**Arkwood, Inc., Superfund Site
Comments on Revised Conceptual Site Model**

Item No.	Reference	Comments by EPA Dated July 18, 2014	PRP Response Dated: August 29, 2014
1.	Revised CSM General	<p>EPA has updated the Standard Default Exposure Factors used by the Superfund program: http://www.epa.gov/oswer/riskassessment/pdf/superfund-hh-exposure/OSWER-Directive-9200-1-120-ExposureFactors.pdf</p> <p>These Standard Default Exposure Parameters are used in the Regional Screening Level (RSL) calculator. http://www.epa.gov/region6/6pd/rcra_c/pd-n/screen.htm</p> <p>The RSL calculator shows, as of May 2014, the updated non-cancer screening level for 2,3,7,8-TCDD toxicity equivalent quotient (TEQ) for an industrial worker is 730 part per trillion (ppt).</p>

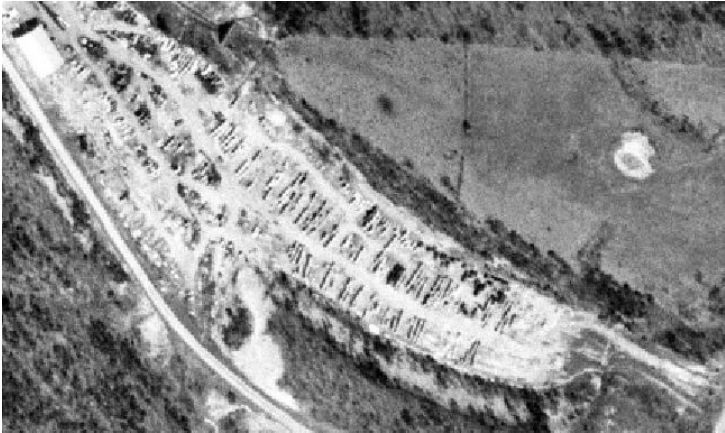
<p>results), no fewer than 10 SU-IS results are needed.</p> <p>c. If the number of SUs in the DU is fewer than these limits, then all SUs should be sampled.</p> <p>2. If the average <u>DU concentration is expected to be far above or below</u> the action level/decision threshold...</p> <p>a. ...and the DU is expected to be <u>fairly homogeneous</u> within its borders (i.e., SUs will probably have similar results), no less than 5 SU-IS results are needed.</p> <p>b. ...and the DU is expected to be heterogeneous within its borders (i.e., SUs will probably have very different results), no fewer than 7 SU-IS results are needed.</p> <p>c. If the number of SUs in the DU is fewer than these limits, then all SUs should be sampled.</p> <p>ii. If the number of SU-ISs actually collected is less than these guidelines, the nonparametric Chebyshev UCL must be used since there is likely insufficient data for reliable results from parametric distribution tests.</p> <p>1. If the Chebyshev UCL exceeds the decision threshold:</p> <p>a. Either the DU must be considered to exceed the threshold, or</p> <p>b. Additional SU-ISs can sampled to add to the data set so that the UCL might be calculated as less than the threshold.</p> <p>2. If the Chebyshev UCL does not exceed the decision threshold:</p> <p>a. Evaluate the actual between-SU variability for this DU <u>AND in</u></p>
